## Comments

Subject  
SITLA Comments on WSR-Draft EIS

Re: Comments on Draft EIS for Wild and Scenic Rivers on USFS Lands in Utah

Re: Comments on the Forest Service's Draft Environment Impact Statement  
Evaluating the Suitability of 86 River Segments on National Forests in Utah for Possible  
Inclusion in the National Wild and Scenic River System.

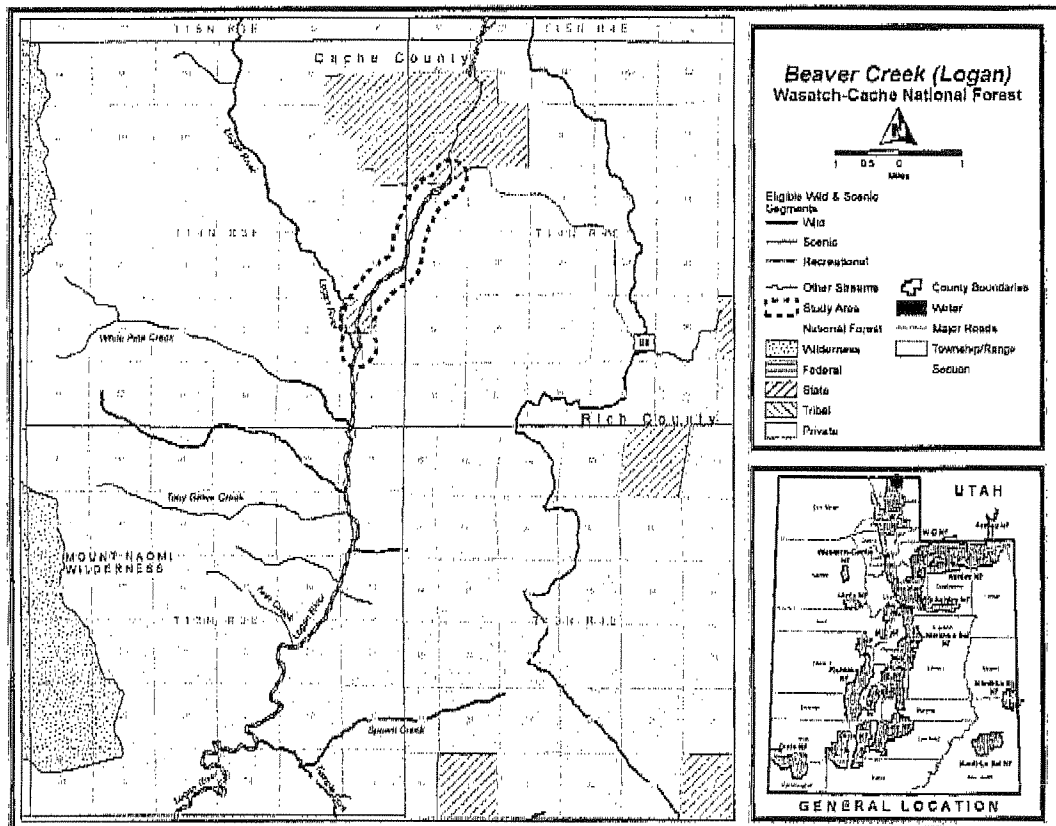
- Beaver Creek: South Boundary of State Land (*Beaver Mountain parcel*) to Mouth (see attached page 524 from Draft EIS for the location of SITLA land – emphasis added in description)
- Logan River: Idaho State Line to Confluence with Beaver Creek (see attached page 508 from Draft EIS for the location of SITLA land)

impacts on the value and utility of its land by unknown or unanticipated consequences of designating these two proposed river segments as described in the Draft EIS. When the final EIS is prepared, SITLA requests that the U.S. Forest Service either:

- a) Withdraw these two proposed river segments from Alternatives 4 and 6, or
- b) Limit the proposed river segments to portions that lie downstream (south) of SITLA's Franklin Basin parcel by using the following revised descriptions:
  - Beaver Creek: South Boundary of State Land (~~Beaver Mountain~~ *Franklin Basin parcel*) to Mouth
  - Logan River: ~~Idaho State Line~~ *South Boundary of State Land* to Confluence with Beaver Creek.
